#### 1 Products affected

#### 2 Type of change

Product Change Notification				PCN KP (Outlet)				
owner	creation date	release date	released by	change order no	rev	page	D40 050 040	
huberth	02.02.2021	02.02.2021	muehlema	2021394	В	1 of 2	D10-052-018

#### 3 Detailed description of change

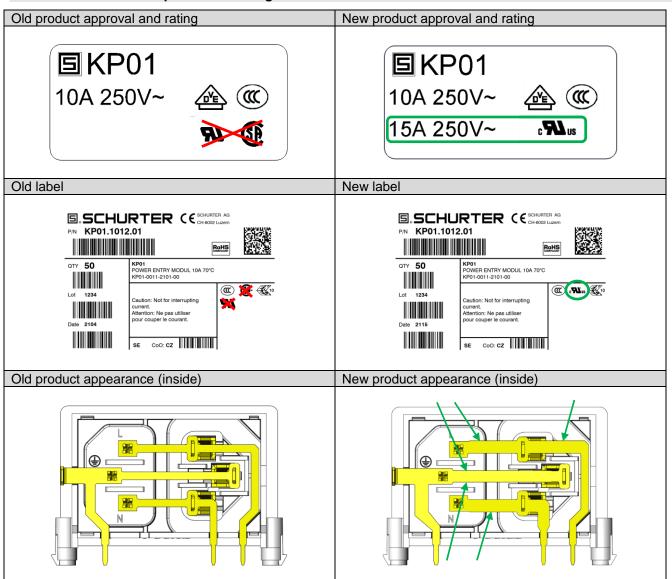
- Change of approval markings from UR and CSA to the combined cURus on the socket and packaging label according standard update to UL/CSA 60320-1.
- Rating for UL changed from 10A to 15A.
- Width of the metal connections increased.

- The change is due to a standard update to UL/CSA 60320-1
- Increase of cross sections to reach nominal current of 15A at UL

Form Yes - Socket and label with new cURus approval marking, UL rating 15A

Metal connections changed

Label Yes Label new with cURus approval marking
